Central Coast
Supplementary Local Planning Panel
Business Paper
04 February 2022

Item No: 2.1
Title: Supplementary Report - DA/221/2014/B - 43 Lot Subdivision to create 40 residential lots, 1 public reserve, 1 detention basin and 1 residue lot (Amended Application) at 31 Aldenham Road, Warnervale

Reference: DA/221/2014/B - D14926779
 Author: Nathan Burr, Senior Development Planner
 Manager: Emily Goodworth, Section Manager Development Assessment North
 Approver: Andrew Roach, Unit Manager, Development Assessment

Figure 1: Proposed Subdivision Plan – Revision F

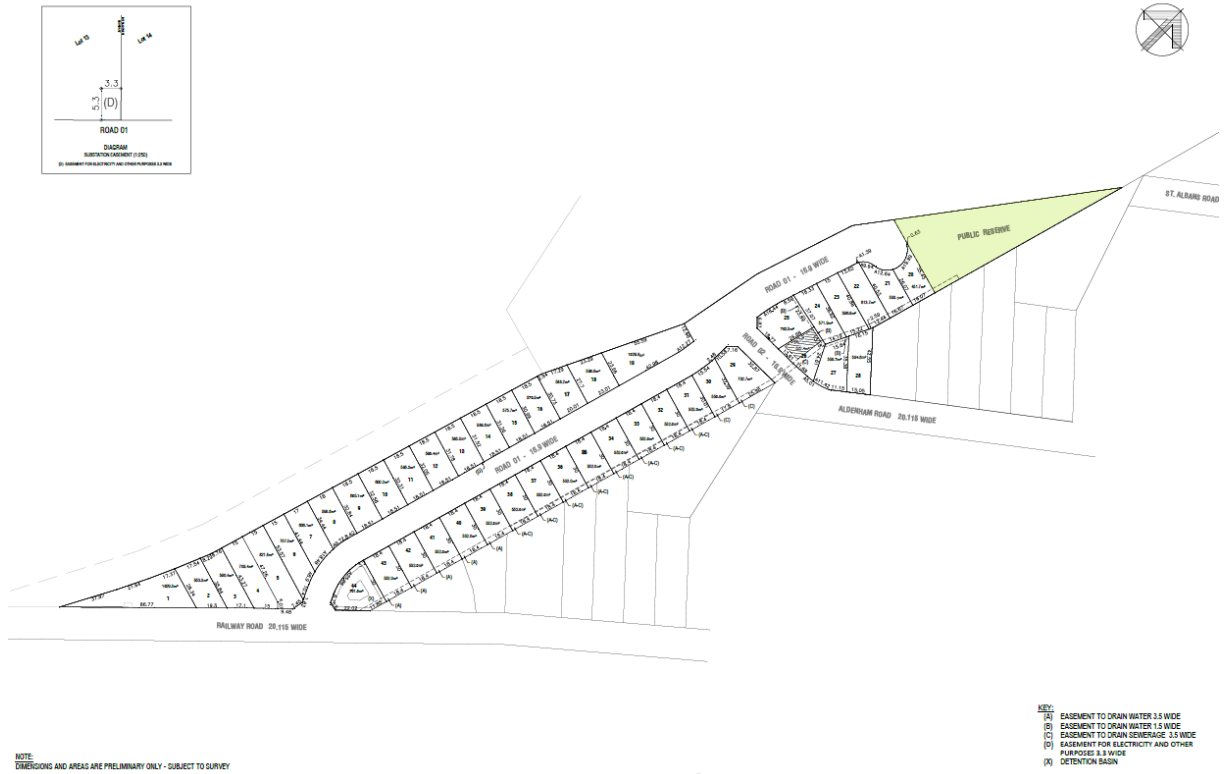
2. *To ensure orderly provision of infrastructure and confirmation of potential encumbrances on proposed Lots 20-28.*

Council Sewer and Water Servicing Strategy Division have advised a straight sewer alignment is preferred. The amended sewer and subdivision plan is now compliant with this requirement. Further, the sewer design is subject to an approval by Central Coast Council Sewer and Water Servicing Strategy Division.

The amended plans propose a straight alignment of the sewer rising main which is consistent with advice received from Council's Water Assessment team.

Figure 2: Proposed Subdivision Plan – Revision F – Lot 26 adjusted Sewer Easement Location and Building Envelope

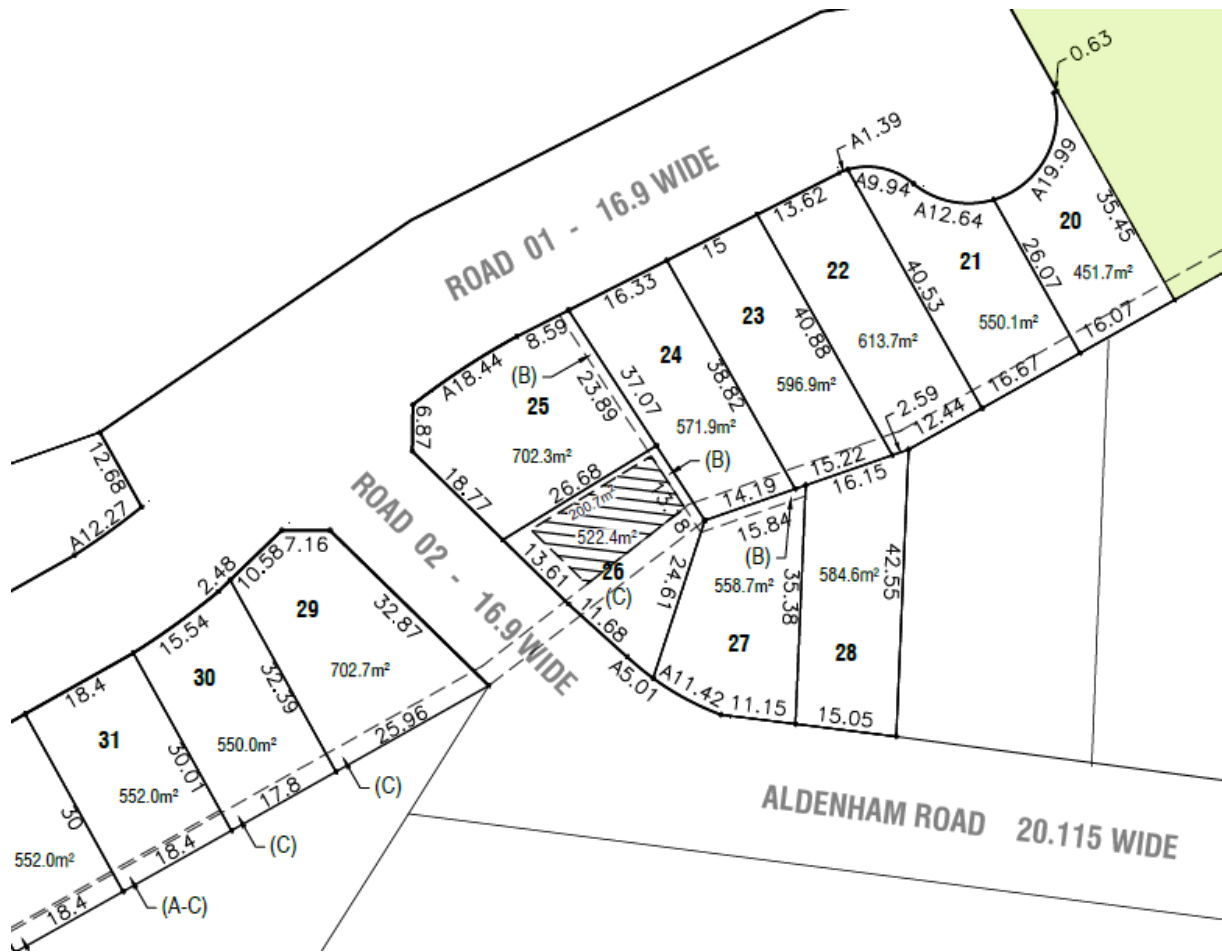
3. *Uncertainty exists in relation to the ability of proposed Lot 26 to adequately cater for future dwelling, given the location of proposed sewer.*

Council's advice has been incorporated in the amended sewer and subdivision plan. A Building Envelope Plan is shown on Lot 26 to accommodate a minimum 200sqm dwelling footprint.

The amended plans identify a 200m² area west of the proposed sewer easement which is considered sufficient land area to erect a dwelling house.
